Access Compliance Report

(Curb Ramps)

Intersection ID: N/A	Main Street: REACROFT_DR	Cross Street: HUNTSCROFT_LN	Location: SW
ADA ID: A3FAE12F8281	Ramp Type: Perp	Initial Pass/Fail: Fail	Overall Compliance: No
Severity Score: 21.25			
Codes/Mitigation Info/Possible Solution		Field Measurements/Component Compliance

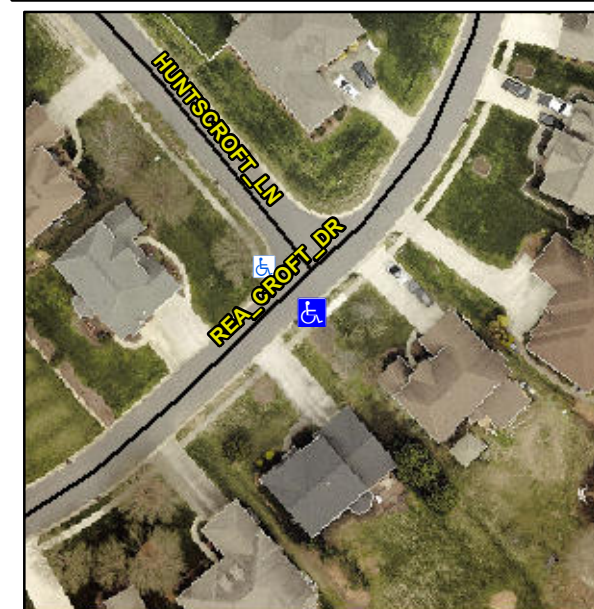
Not Found, R304.5.1, R304.2.2

Compliance	Description	Data	Compliance	Description	Data
N/A	Ramp Length (in)	49.0	No	Ramp Slope (%)	10.1
No	Ramp Width (in)	46.0	Yes	Ramp XSlope (%)	1.7
N/A	Flare Type LT	N/A	N/A	Flare Type RT	N/A
N/A	Flare Slope LT (%)	N/A	N/A	Flare Slope RT (%)	N/A
N/A	Flare Traversable LT?	N/A	N/A	Flare Traversable RT?	N/A
N/A	Landing Length (in)	N/A	N/A	DWS Provided?	N/A
N/A	Landing Width (in)	N/A	N/A	DWS Contrast?	N/A
N/A	Landing Slope (%)	N/A	N/A	DWS Length (in)	N/A
N/A	Landing X Slope (%)	N/A	N/A	DWS Full Width?	N/A
N/A	Landing Curb? (Y/N)	N/A	N/A	DWS Offset (in)	N/A
N/A	Shared Landing?	N/A			
N/A	Gutter Ponding?	N/A	N/A	Gutter Slope (%)	N/A
N/A	Gutter Lip Ht (in)	N/A	N/A	Gutter X Slope (%)	N/A
N/A	Painted X Walk1?	No	N/A	Painted X Walk2?	N/A
	X Walk 1 Direction	To NW		X Walk 2 Direction	N/A
N/A	X Walk 1 Width (in)	N/A	N/A	X Walk 2 Width (in)	N/A
	X Walk 1 Slope (%)	3.7		X Walk 2 Slope (%)	N/A
	X Walk 1 X Slope (%)	2.0		X Walk 2 X Slope (%)	N/A

Remove & Replace Entire Ramp.
